Access Compliance Report

Public Rights-of-Way

(Curb Ramps)

Intersection ID: 13714	Main Street: HANOVER_ST	Cross Street: MCCLINTOCK_RD	Location: SE
ADA ID: 7B09338F2CBF	Ramp Type: BlendTrans1	Initial Pass/Fail: Pass	Overall Compliance: No
Severity Score: 17.5			
Codes/Mitigation Info/Possible Solution		Field Measurements/Component Compliance

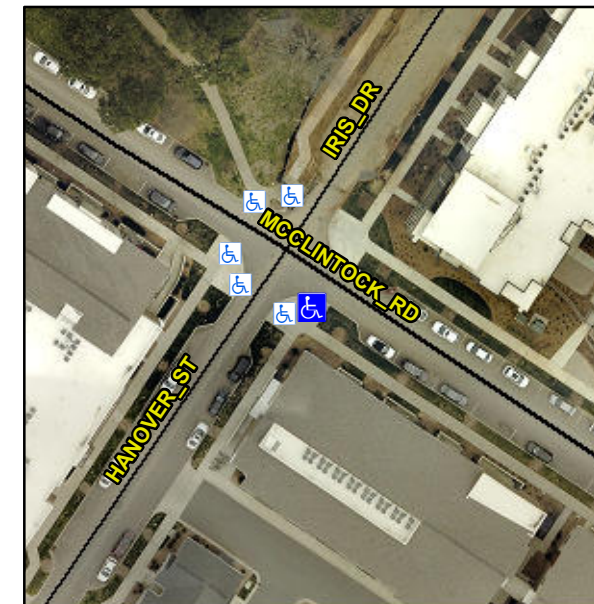
R304.5.3, R305.1.4, R305.2, R302.7.2

Remove & Replace Curb Ramp With Two New Directional Ramps or Equivalent. Grind Gutter Lip.
